Urban Design Consultation

Proposal: Discharge of conditions 2 (Materials - main development site), 4, (Architectural Details - main development site), 7 (Parking bollards), 8 (Hard Landscaping), 9 (Road details), 12 (Bin Collection Points), 13 (Car Parking Demarcation), 16 (Substation) for 23/00369/REM	**Location: Land North Of 16 The Bank Somersham**
Case Officer: Kevin Simpson	**Application: 24/80435/COND**

Facing bricks (left to right) – 'Village Harvest Buff', 'Village Oatmeal Buff', and 'Clumber Red Mixture':

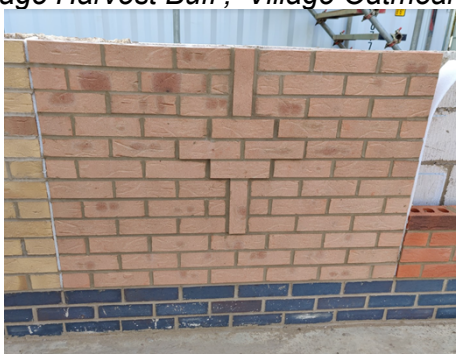
The distribution of facing bricks shown on the submitted Charter Plan Rev N largely accords with the approved drawing (Rev K), however concern was raised regarding the Village Oatmeal Buff which appeared overly pink on site – as such the distribution of facing bricks has been amended to reduce the number of units in Oatmeal Buff.

These changes are accepatble and are as discussed with Georgia McCrae (Allison Homes) on site on the 28/11/2024.
